LEON CREEK WRC IMPROVEMENTS AND UPGRADES PHASE 2

Solicitation Number: CO-00386

ADDENDUM 3

March 4, 2021

DRAWING NUMBER
10-D128

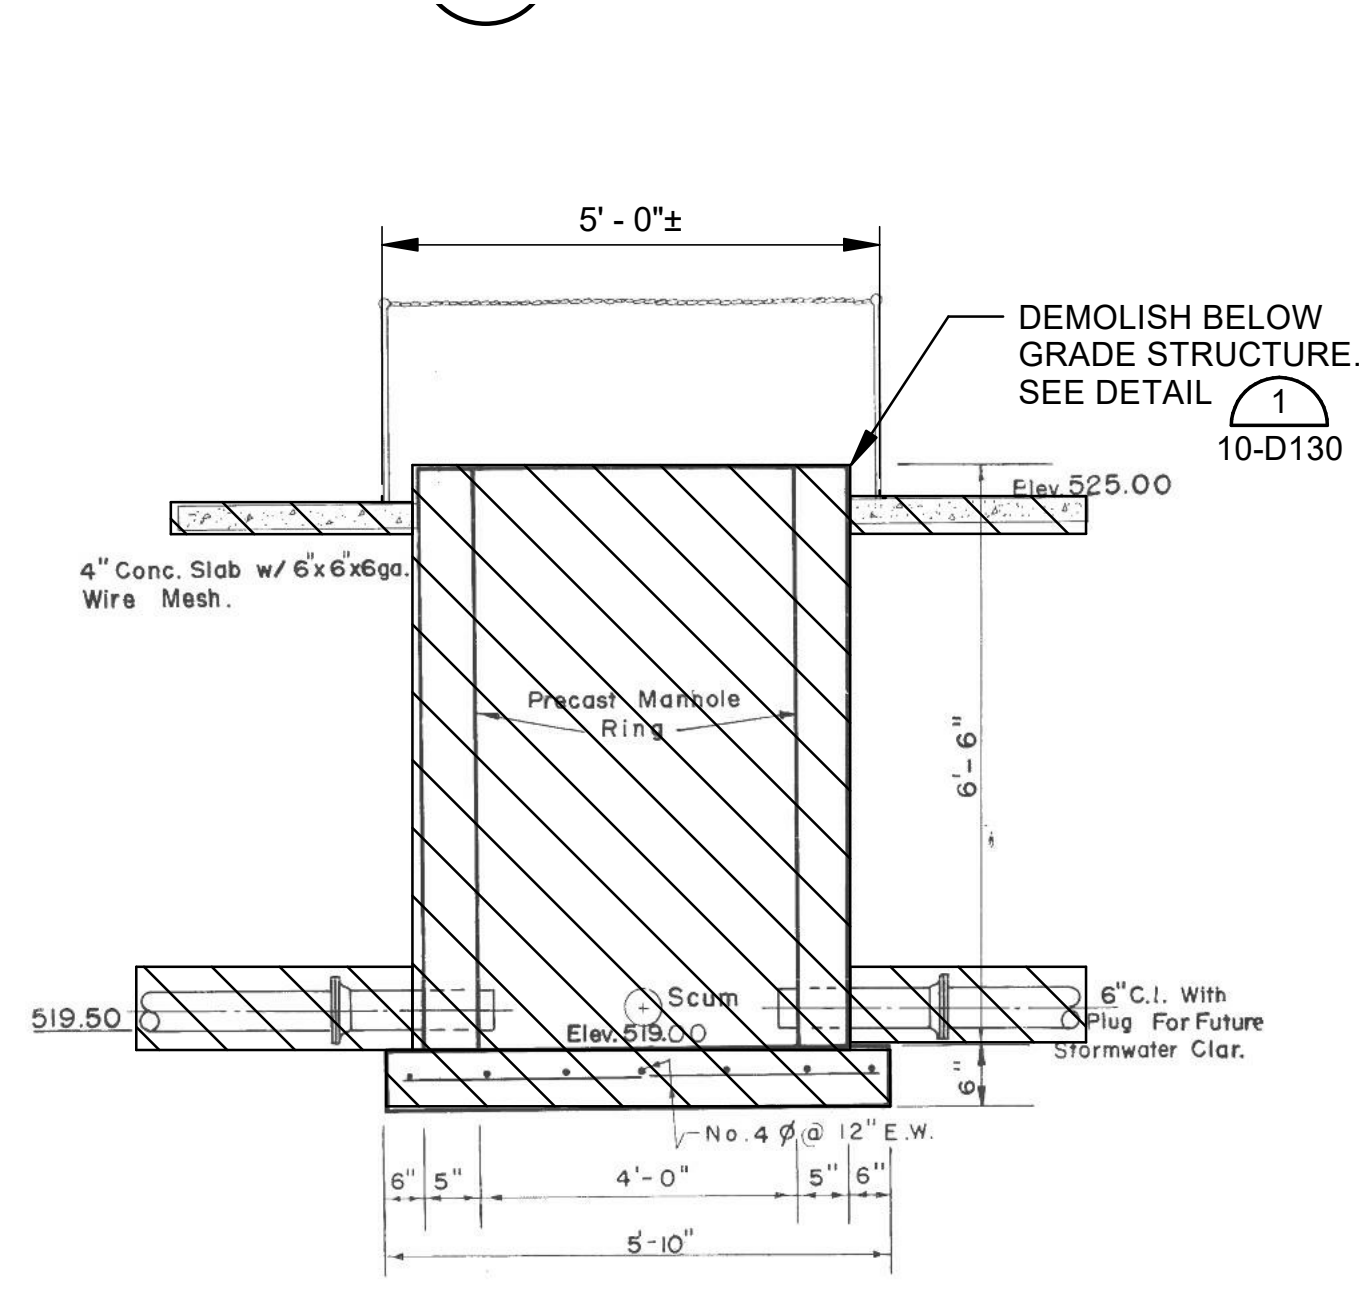
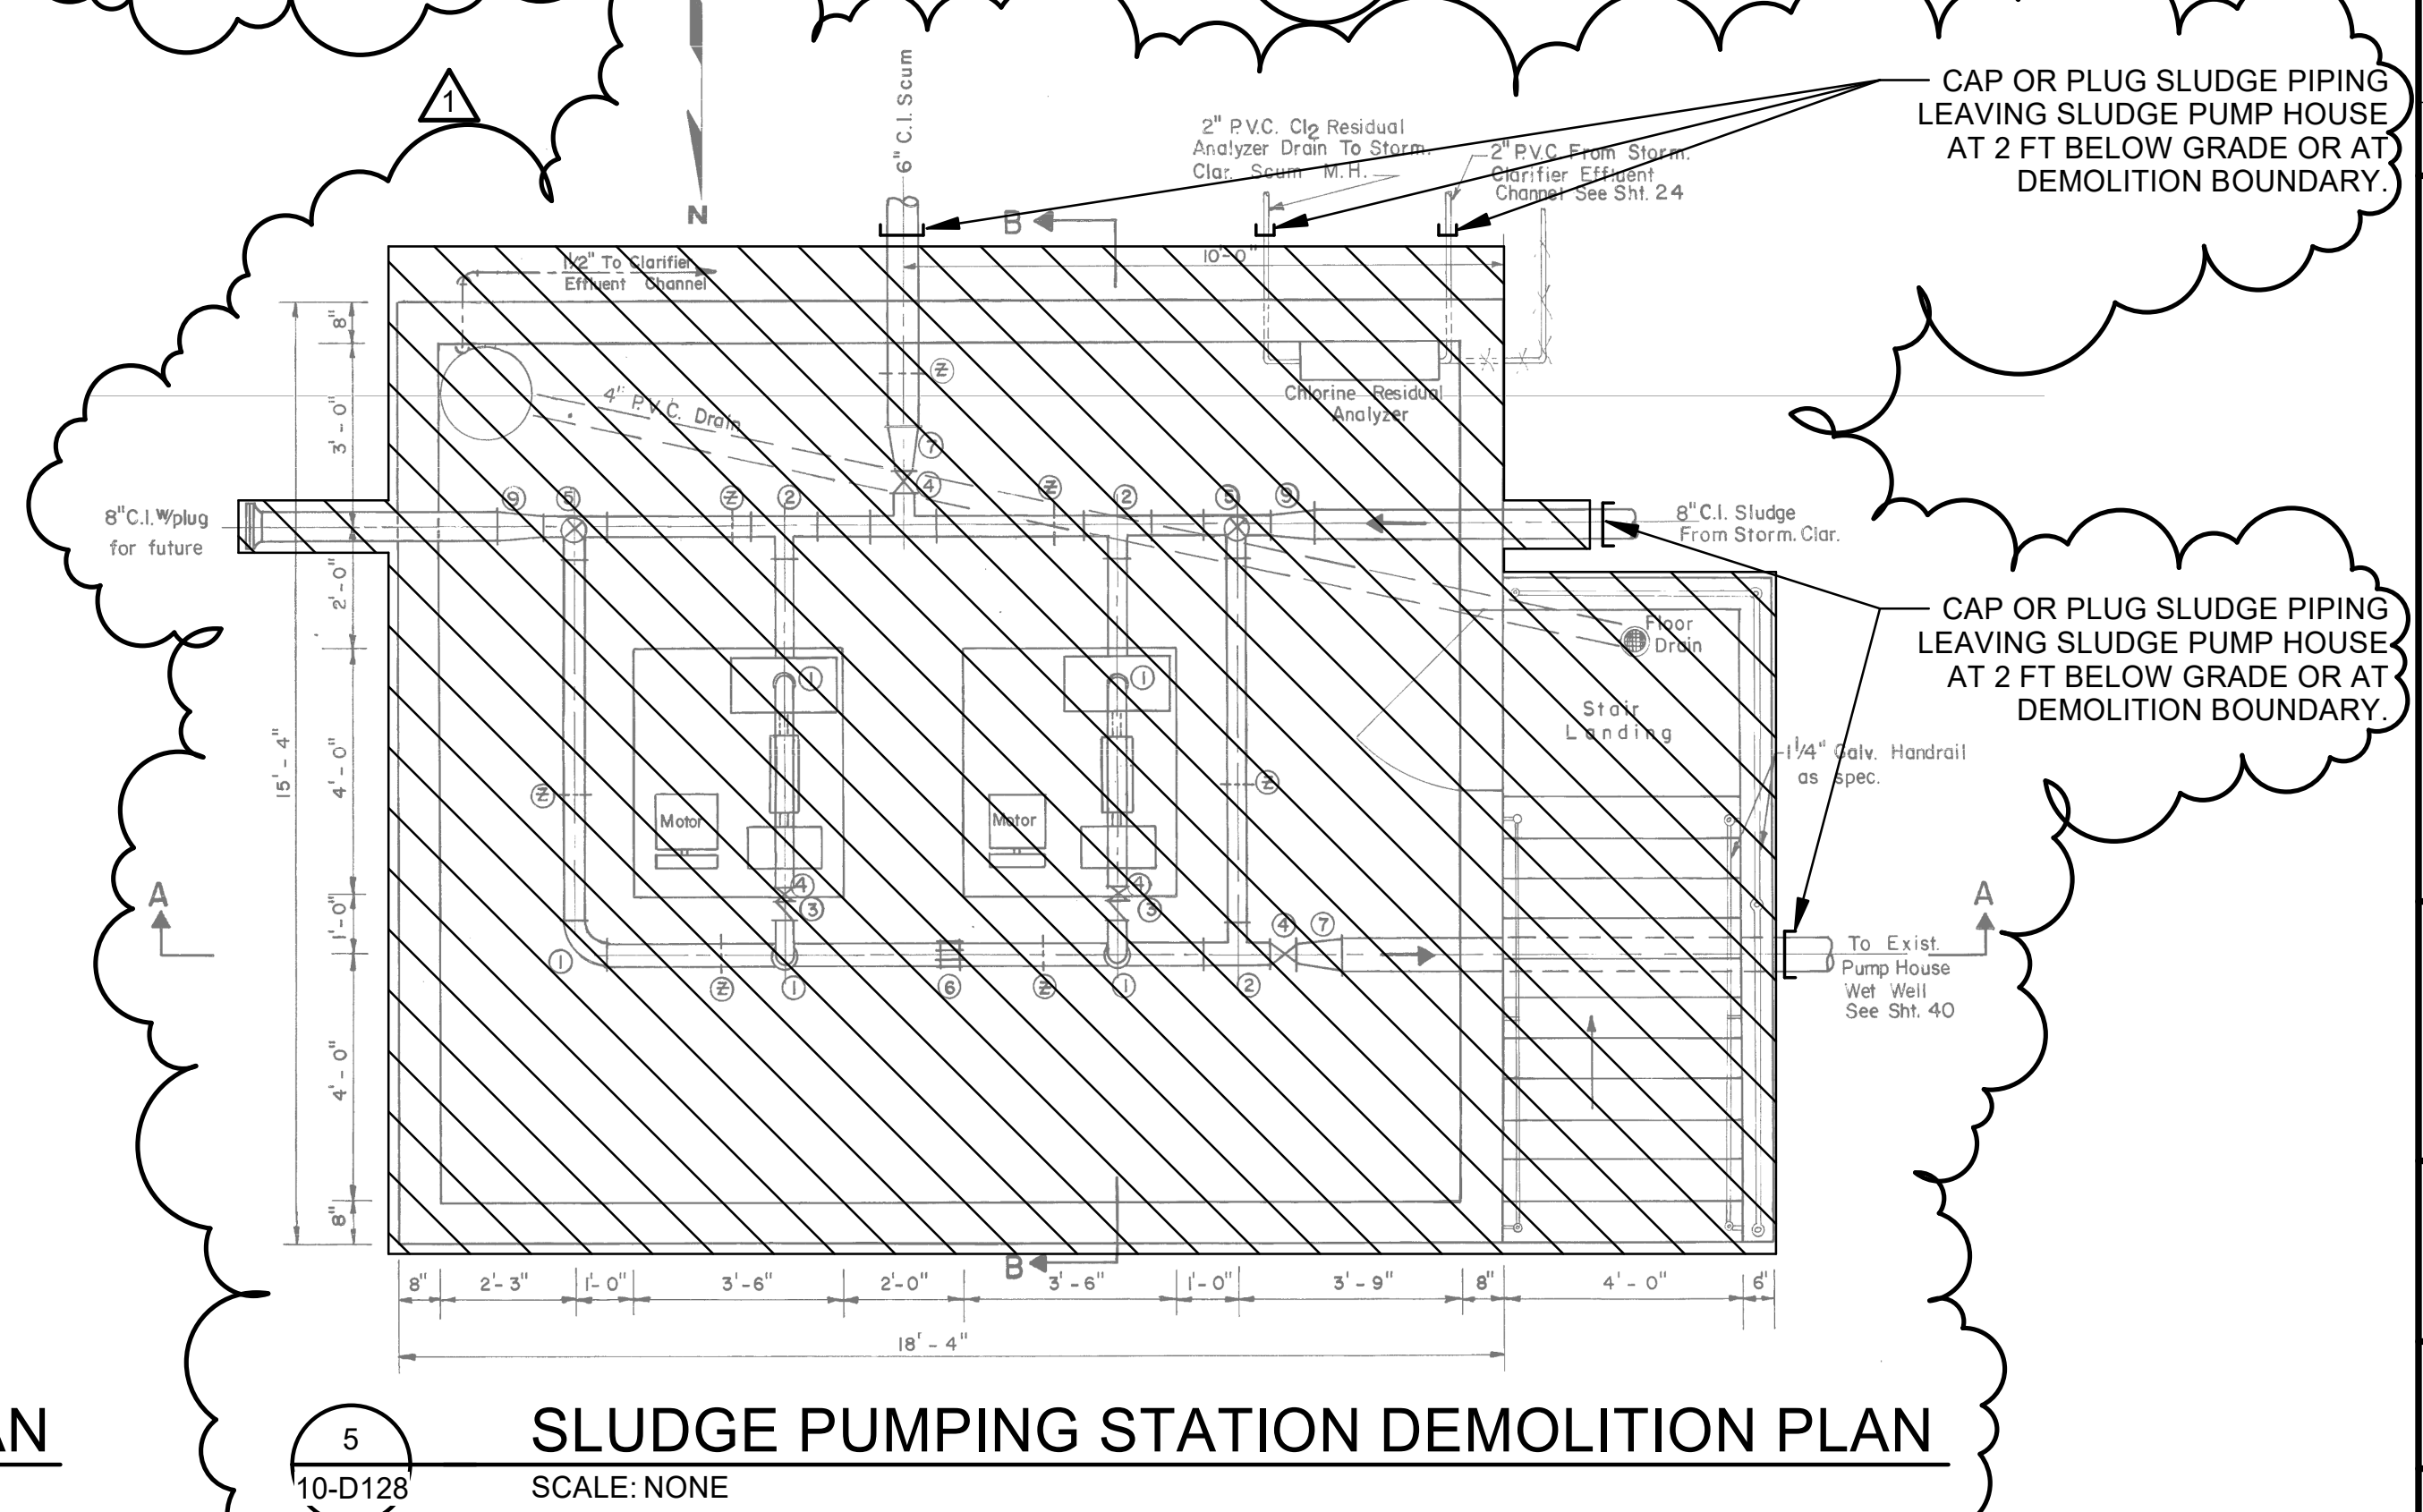
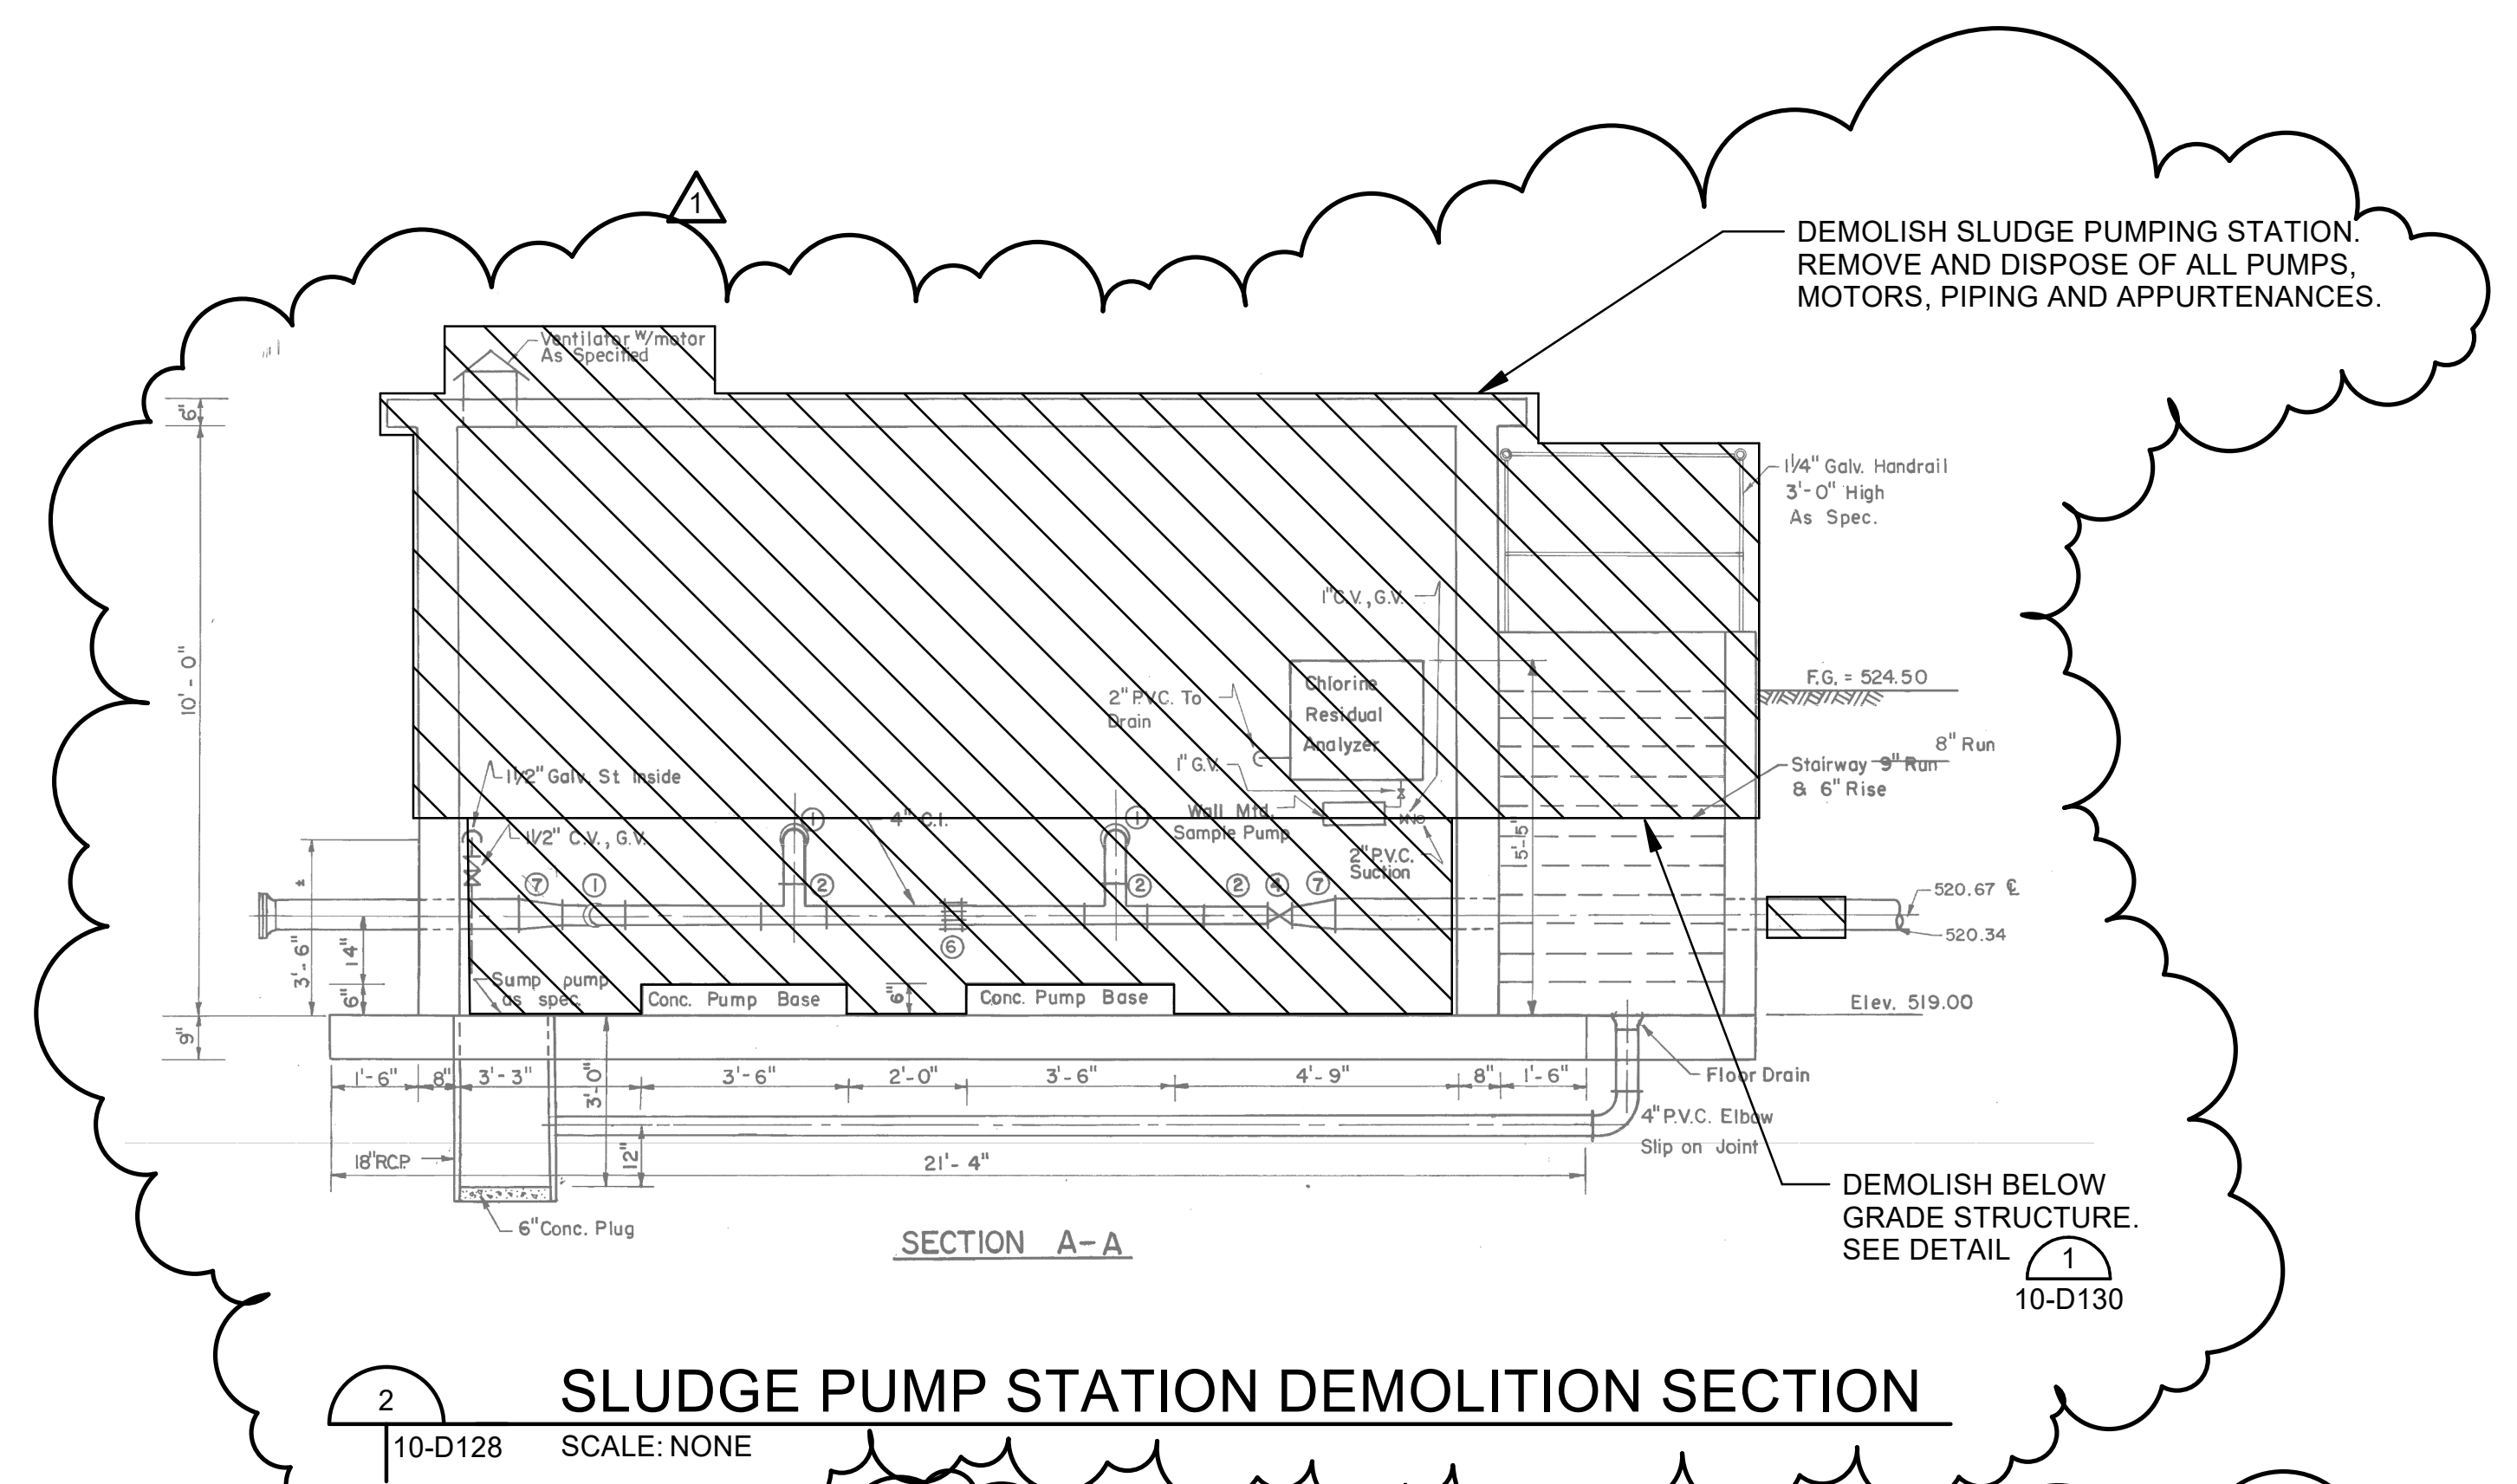
Please provide dimensions of the sludge pump station to be demolished on Sheet 10-D128.

Response: Plan and section views with dimensions have been added. Please see No. 5 in the Changes to Plans portion of this Addendum.
